Supplementary Information

To: Hunter and Central Coast Regional Planning Panel

Subject: Pre E-determination – DA/2371/2023 12-14 Jennings Road, Wyong

Date: 2 October 2025

Figure 1: COS proposed

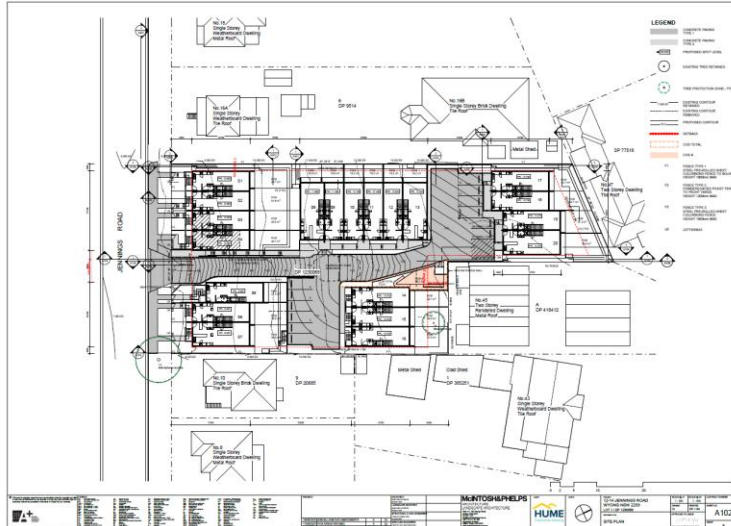
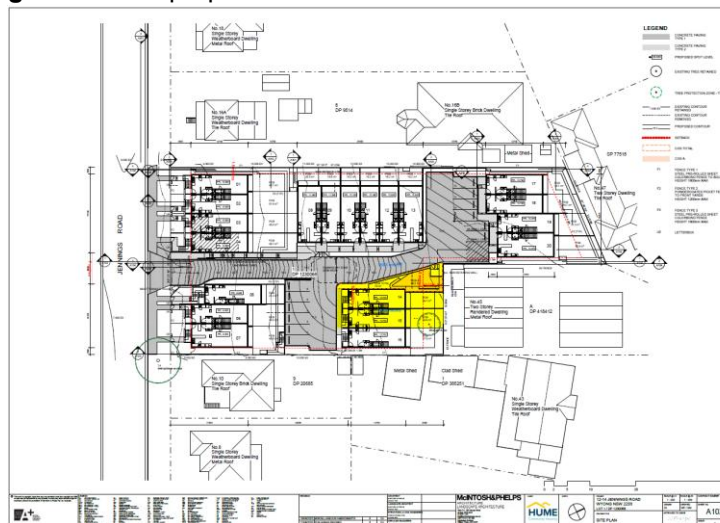
2.2.7.4 Common Open Space – Multi Dwelling Housing and Attached Dwellings		
Communal open space required where more than 10 dwellings	70m ² is proposed. The COS is to be refined to include usual community space activities such as planters for community gardens, areas for play space/equipment, bench seating and pergolas or shade structures.	No
Communal open space on no more than 2 locations at rate of 10m ² per dwelling and minimum 5m width.	200m² required: 20 dwellings x 10m² = 200m² of COS with a minimum dimension of 5 metres. None of the COS provided has a minimum dimension of 5 metres in both directions. In order to provide the required amount of COS, 2 dwellings (Nos 14 and 15) would need to be deleted. This would provide 266m² of COS with the required minimum dimension (if consolidated with the existing COS). If dwelling No. 14 only is deleted, this would provide 166m² of COS (which is under the minimum requirement). Given that most of the dwellings do not have POS of the required minimum size and dimension. This is indicatively shown below in the before and after scenarios.	No

Figure 2: COS recommended
